PROPOSED CHRISTMAS FARM, LAND TO THE SOUTH OF LLAY ROAD, CEFN-Y-BEDD, WREXHAM

PLANNING APPLICATION REFERENCE P/2022/0681

Introduction

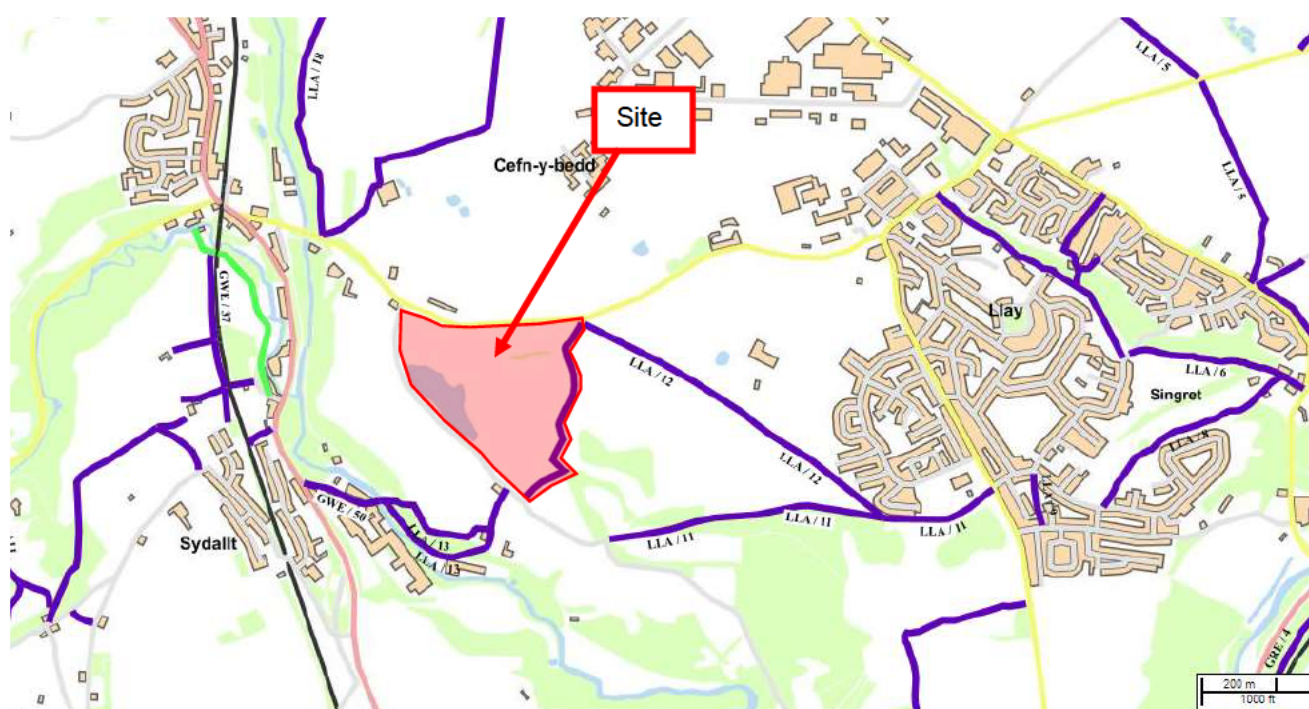
Turning to one of the other comments provided in regard to the width of the footway on Llay Road, this suggests that the footway is 800mm wide and so less than the “1.8m – 2m normally specified”.

It is nonetheless incorrect to say that the existing footway along Llay Road is only 800mm wide. The existing footway has, over time, become overgrown by vegetation and grass from the verge, which currently limits its effective width to around 800mm. The applicant has conducted a check of the *actual* effective footway width that would be available if this overgrown vegetation were removed and properly maintained. This was achieved by removing the overgrown vegetation with a spade at 7 selected points in the vicinity of the site.

The results of this exercise are set out on the notes within Enclosure 2 to this letter. It demonstrates that the actual footway width would be 1m or more to the east of the site access, towards Llay, and around 1m wide to the west of the site access.

Whilst this increased width might not ostensibly seem consequential, a 1m footway width is deemed to be the minimum width deemed to be necessary within the DfT’s “Inclusive Mobility” document dated 2002.
